# **CITY OF SARATOGA ARBORIST APPROVAL**

Conditions of Approval and Tree Protection Plan

Address: 14486 Oak Place
Owner: Deepak Chandani
APN: 397-22-005

Date: September 24, 2024

> ARBORIST REPORT pg. 20

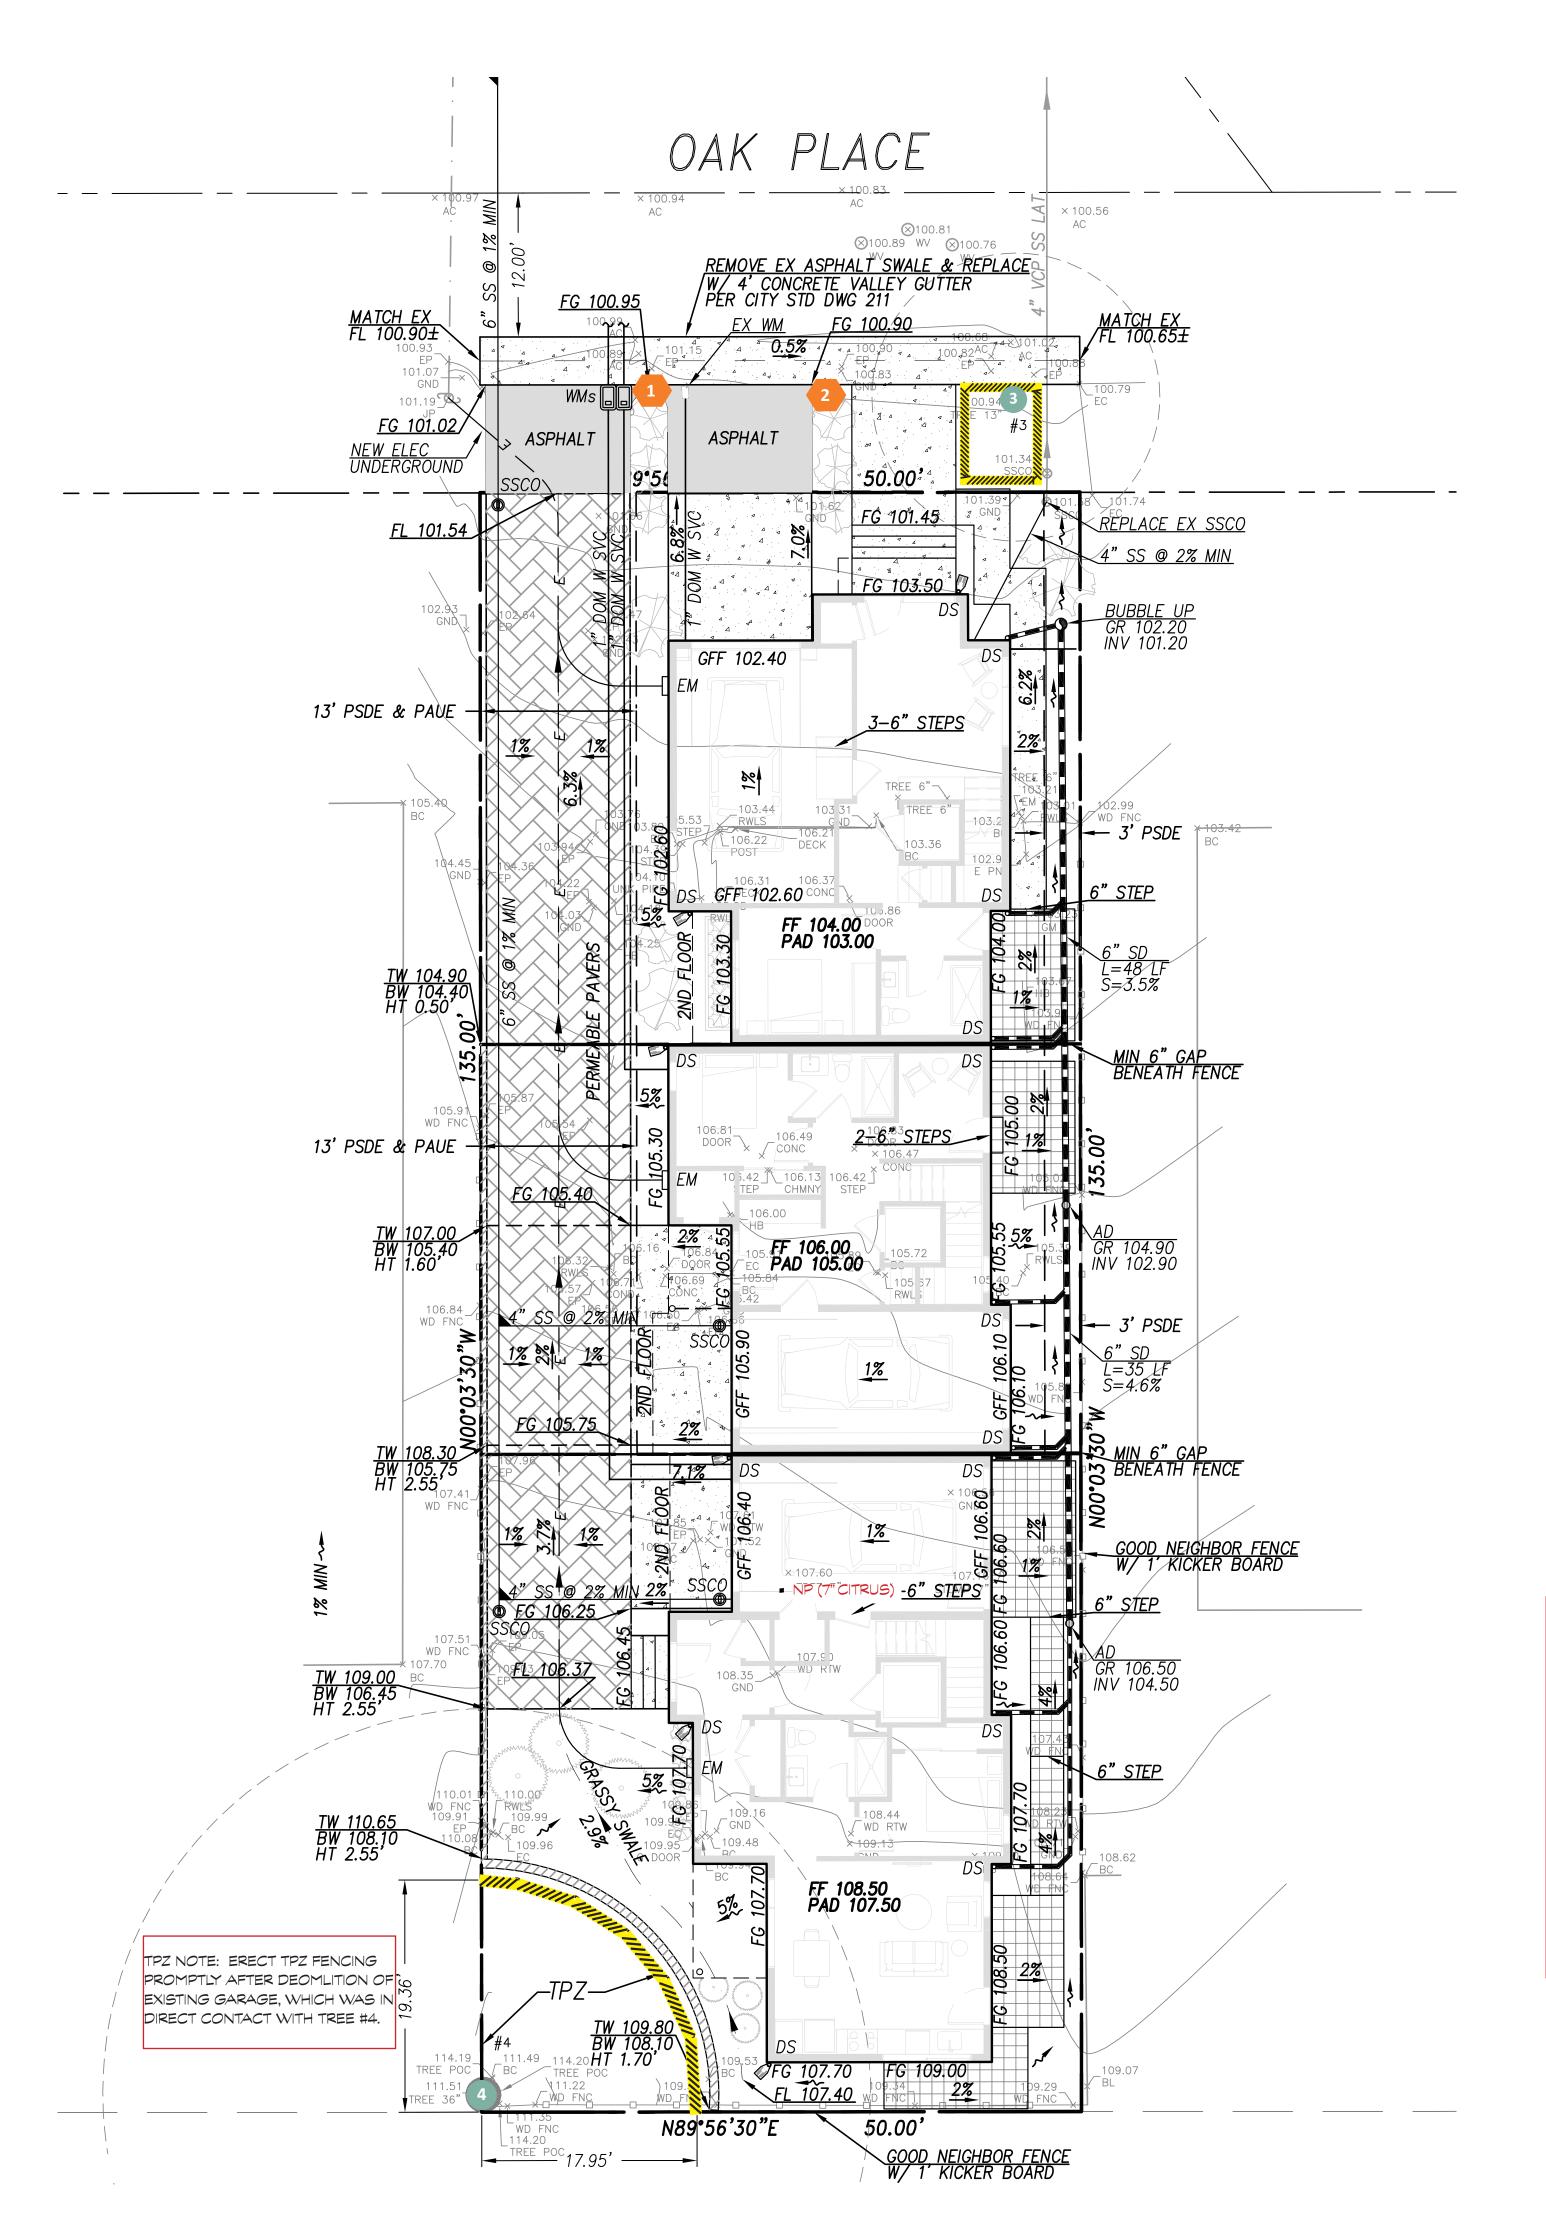
- a) Shall be installed as shown on the attached map.
- b) Shall be shown on the Site Plan.
- c) Shall be established prior to the arrival of construction equipment or materials on site.
- d) Shall be comprised of six-foot high chain link fencing mounted on 2-inch diameter galvanized posts, driven into the ground and spaced no more than 10 feet apart.
- e) Shall be posted with signs saying, "TREE PROTECTION FENCE DO NOT MOVE OR REMOVE WITHOUT APPROVAL FROM CITY ARBORIST, CHRISTINA FUSCO (408) 868-1276".
- f) A letter/email shall be provided to the City from the project arborist confirming the correct installation of the tree protection fencing once it has been installed, including photos. This is required prior to obtaining building division permits.
- g) Tree protection fencing shall remain undisturbed throughout the construction until final inspection.
